Staff Report to the Technical Review Committee May 5, 2015

Minor Subdivision request to plat the property into 4 lots for an attached dwelling development.

Property Location: 1322 Noble Pl.

TOWNHOMES AT NOBLE PLACE

PROPOSED PLAT

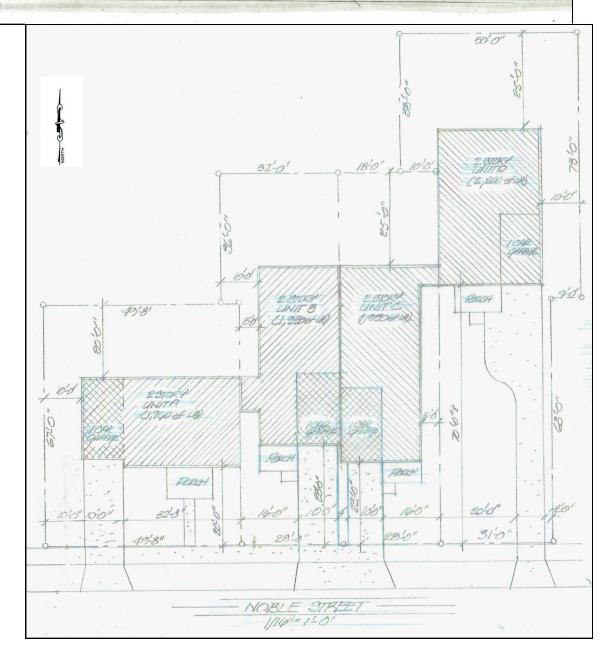
- 4. Sheet: (Plat) Note 4. Needs to be in the dedication.FS 177.091 (12)
- 5. Sheet: (Plat) Lots 18,21 and remainders of 19 &20 have plat book G 71 as the reference.

1. Note 4 should be shown in the dedication block as it is a public dedication.
